ADDENDUM NO. 1

**ARCADIA HIGH SCHOOL
LOCKER ROOM ALTERATION
ARCADIA UNIFIED SCHOOL DISTRICT**

tBP/ARCHITECTURE
4611 Teller Avenue
Newport Beach, CA 92660
949-673-0300

This Addendum forms a part of the Contract Documents and modifies the original Bidding Drawings dated August 15, 2024, and Specifications dated July 2024. Acknowledge receipt of this Addendum in space provided on the Bid Form. Failure to acknowledge may subject Bidder to disqualification.

E6.1

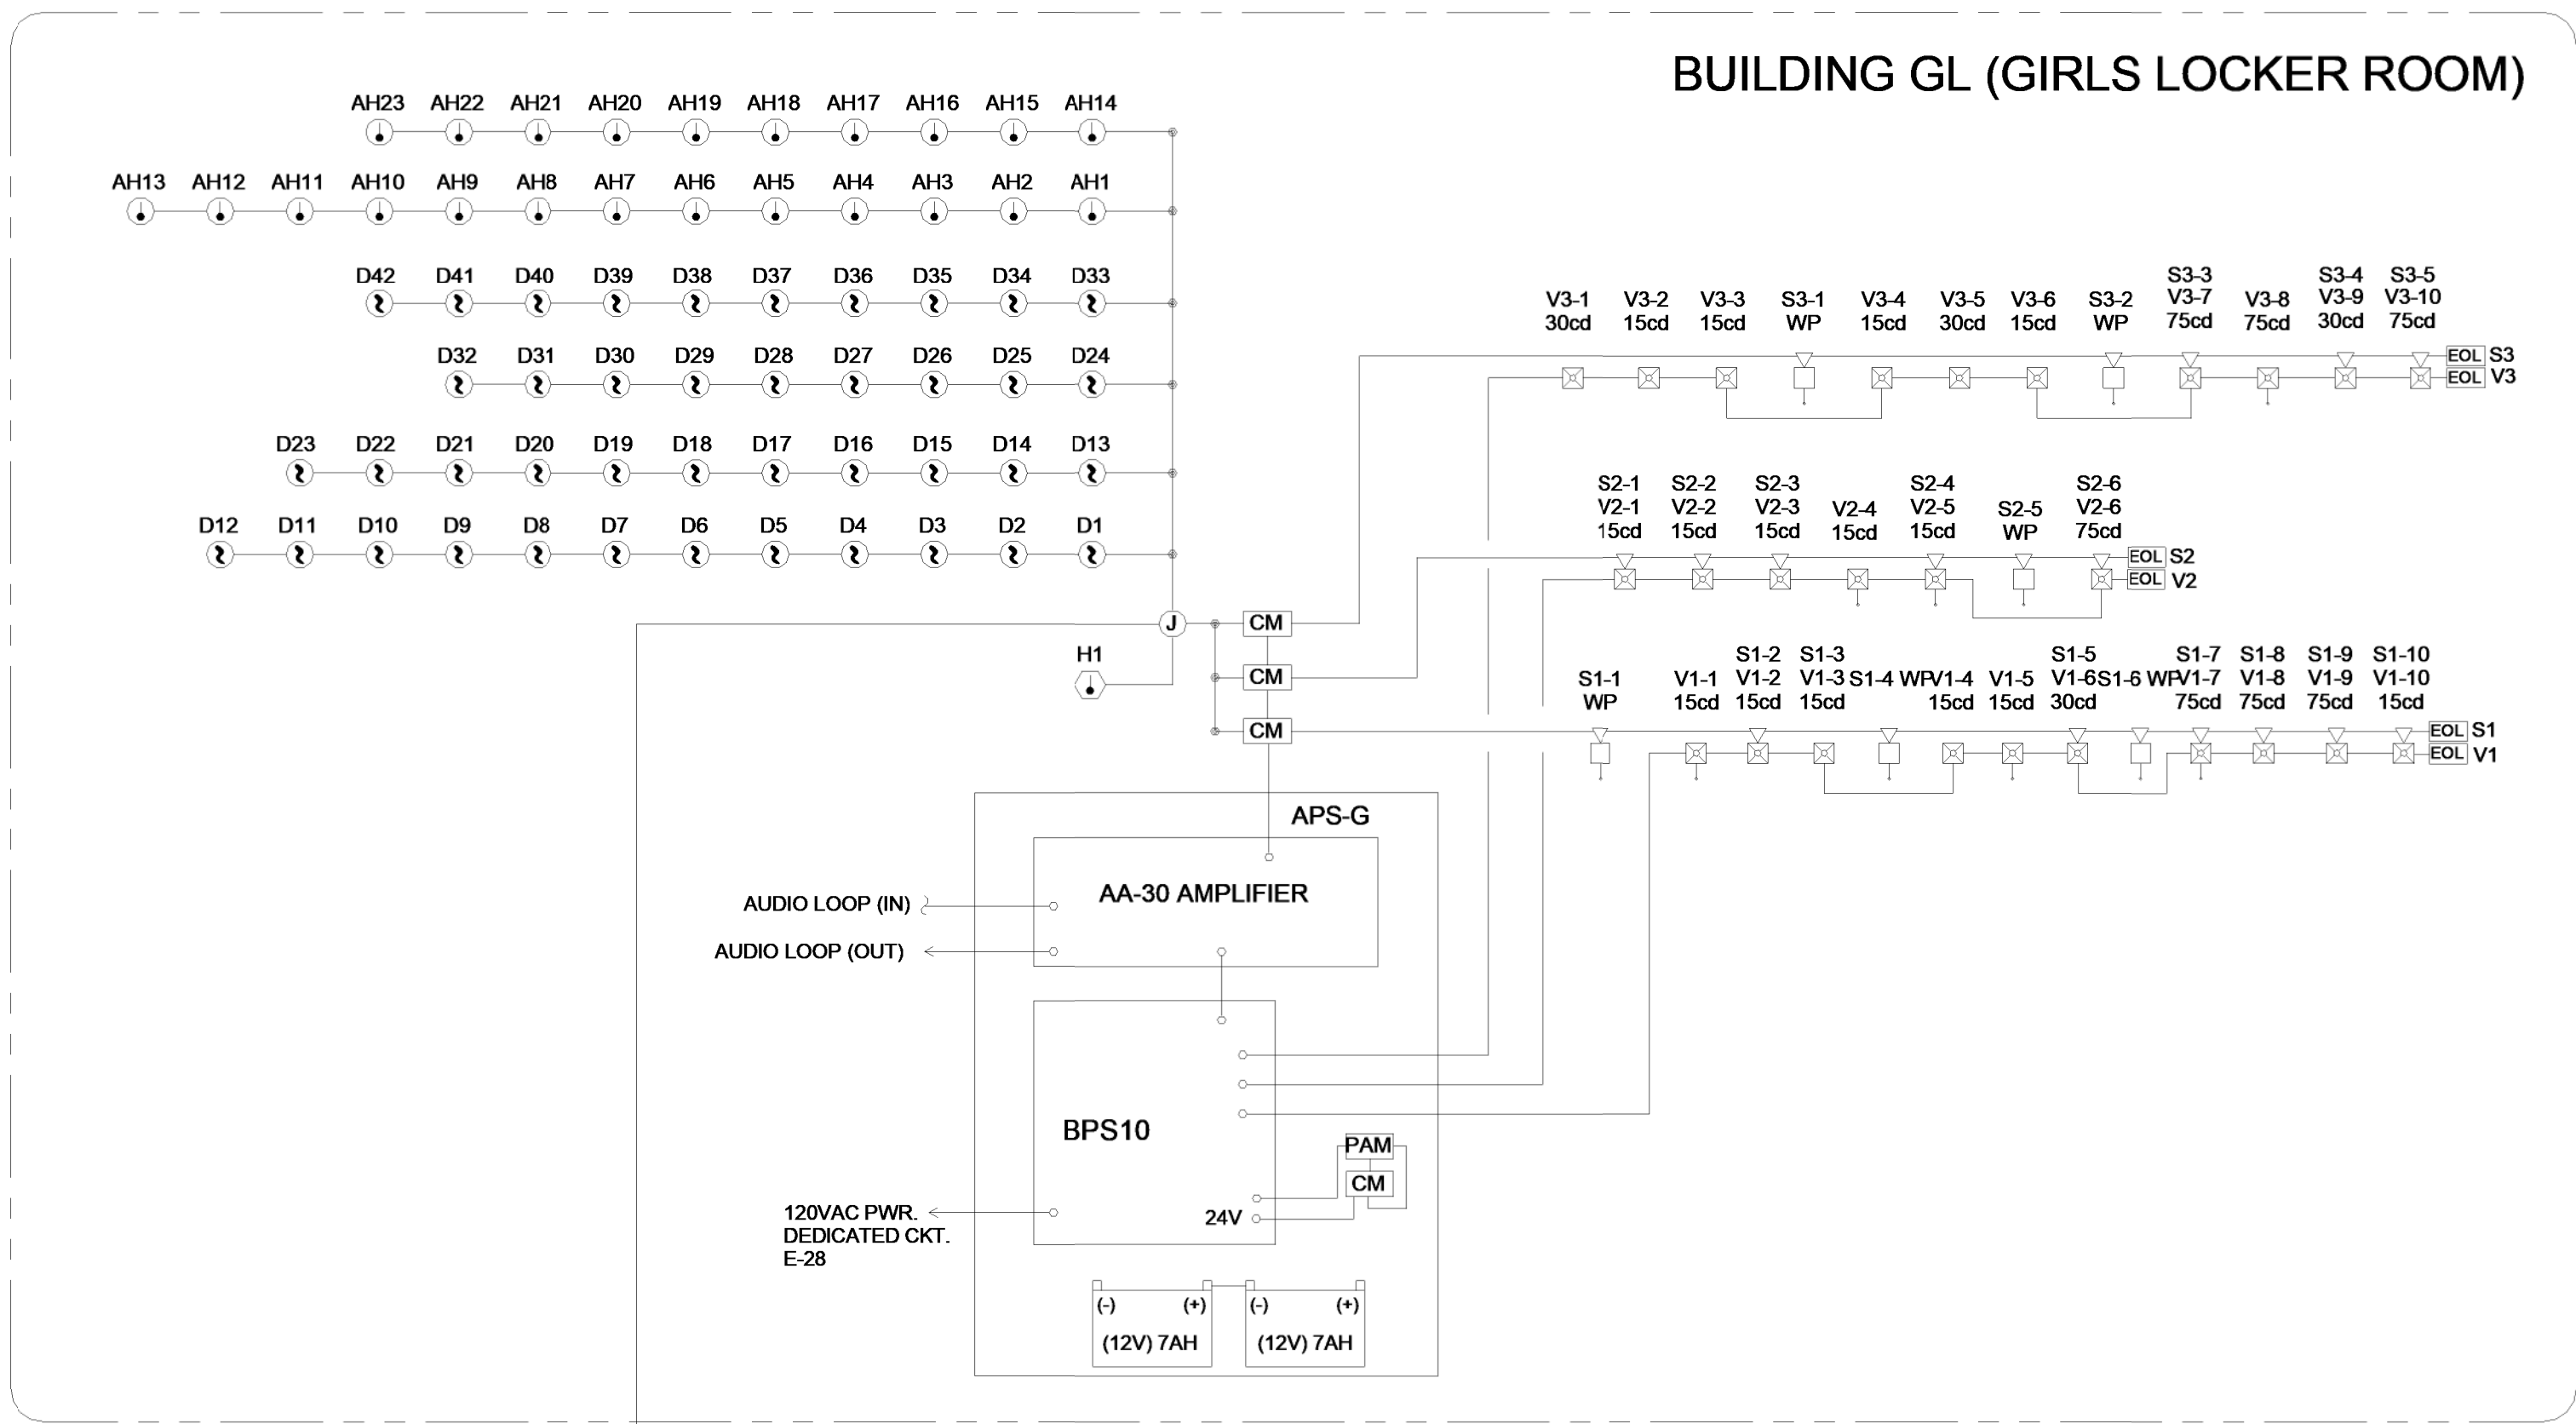
- a. Revise electrical connection to EF/BL5 and EF/BL9 in Building BL.
 - b. Revise electrical connection to EF/GL6 and EF/GL10 in Building GL.
33. SHEET E6.1 – BUILDING BL & GL FIRE ALARM PLAN
Replace full size sheet drawing **E6.1** in its entirety, issued with this addendum.
Changes include:
